Re: Natural Gas Activities

PG&E's Comments on
CEC Draft Staff Paper on Natural Gas Infrastructure

June 5, 2009

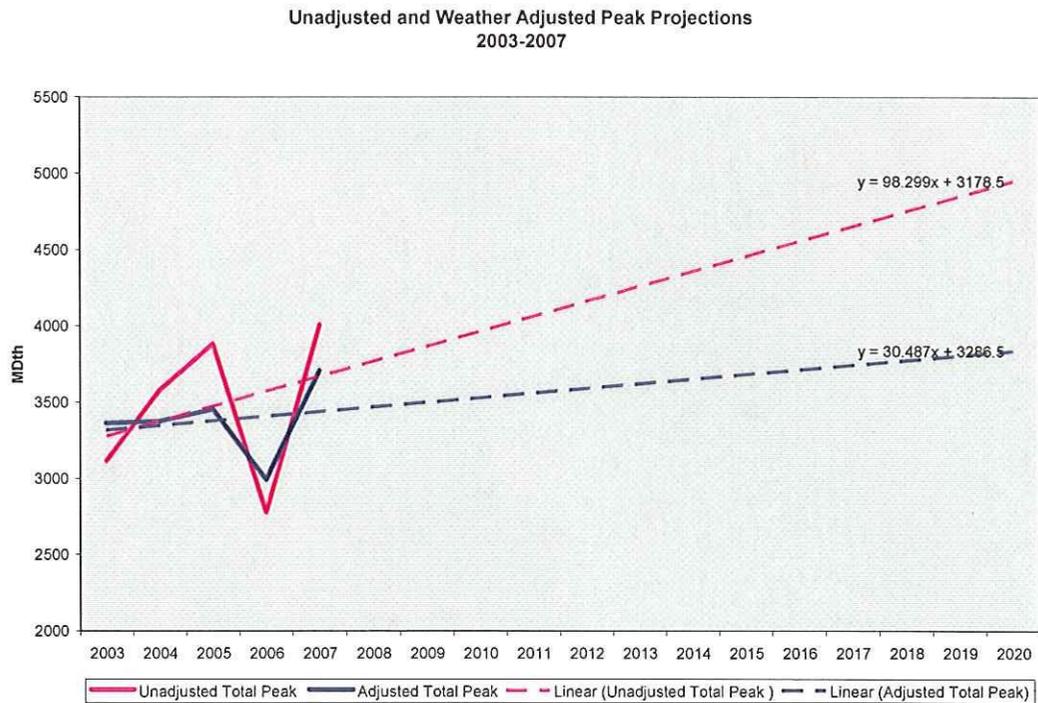
The Draft Report indicated a concern that the peak sendout between 2003 and 2007 increased, while the forecast of winter peak demand in the Cal Gas Report was relatively flat. PG&E's forecast of winter demand used by the CEC (Cal Gas Report, page 48) represents the average daily demands in the peak month in a 1-in-35 year, but not the peak demand in a year.

This trend analysis represents a good starting point, but the gas demand data needs to be adjusted for temperature and should also include other variables, such as economic conditions. As an example of adjustments, an analysis of the relationship between Heating Degree Days (HDDs) and maximum gas sendout in January shows a high correlation over that period. Because 2003 was a relatively warm peak and 2007 was a relatively cold peak, the forecast trend is higher than if normalized for temperature.

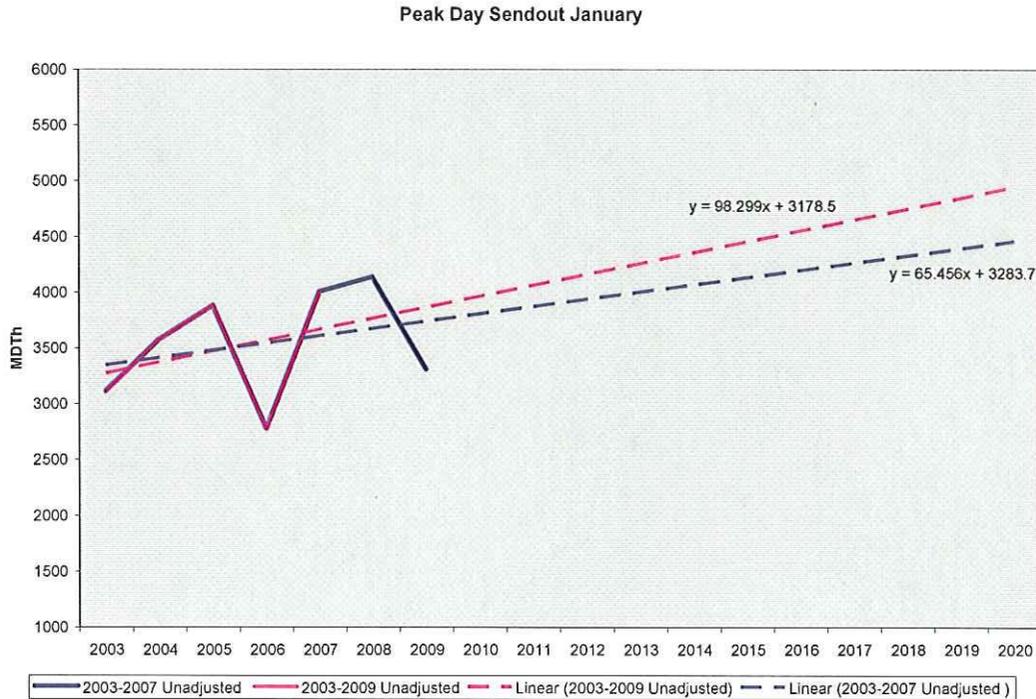
PG&E constructed a regression of total peak day send out in January and HDDs from 2003-2007 (see graph below). While there are many other factors affecting sendout, such as the economy, the R-squared of the equation was .58, indicating that we can explain 58% of the variation in Total Daily Sendout in January with HDDs. The equations for this analysis are provided in Appendix 1.

Normalizing the data in the trend analysis shows a flatter trend for the PG&E Service Area, as shown on the graph below.
